Access Compliance Report

Public Rights-of-Way

(Curb Ramps)

Intersection ID: 4394	Main Street: OLD_STATESVILLE_RD	Cross Street: VICTORIA_AV	Location: SE
ADA ID: 2549A263CB03	Ramp Type: Perp	Initial Pass/Fail: Fail	Overall Compliance: No
		Severity Score: 25

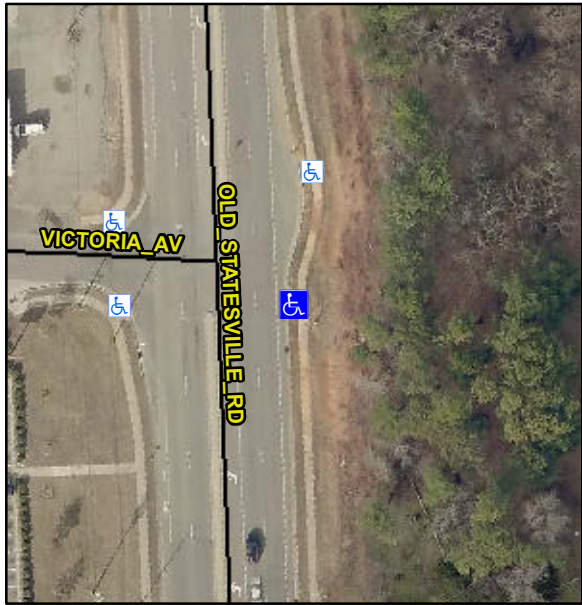
Codes/Mitigation Info/Possible Solution			Field Measurements/Component Compliance					
	Possible Solutions:		Compliance	Description	Data	Compliance	Description	Data
	Remove & Replace Entire Ramp.		N/A	Ramp Length (in)	61.0	No	Ramp Slope (%)	20.0
			Yes	Ramp Width (in)	48.0	Yes	Ramp XSlope (%)	1.1
			N/A	Flare Type LT	N/A	N/A	Flare Type RT	N/A
			N/A	Flare Slope LT (%)	N/A	N/A	Flare Slope RT (%)	N/A
			N/A	Flare Traversable LT?	N/A	N/A	Flare Traversable RT?	N/A
			N/A	Landing Length (in)	N/A	N/A	DWS Provided?	N/A
			N/A	Landing Width (in)	N/A	N/A	DWS Contrast?	N/A
			N/A	Landing Slope (%)	N/A	N/A	DWS Length (in)	N/A
			N/A	Landing X Slope (%)	N/A	N/A	DWS Full Width?	N/A
Surveyor Notes:		N/A	N/A	Landing Curb? (Y/N)	N/A	N/A	DWS Offset (in)	N/A
		N/A	N/A	Shared Landing?	N/A			
PROW/ADA:		N/A	N/A	Gutter Ponding?	N/A	N/A	Gutter Slope (%)	N/A
		Not Found, R304.2.2	N/A	Gutter Lip Ht (in)	N/A	N/A	Gutter X Slope (%)	N/A
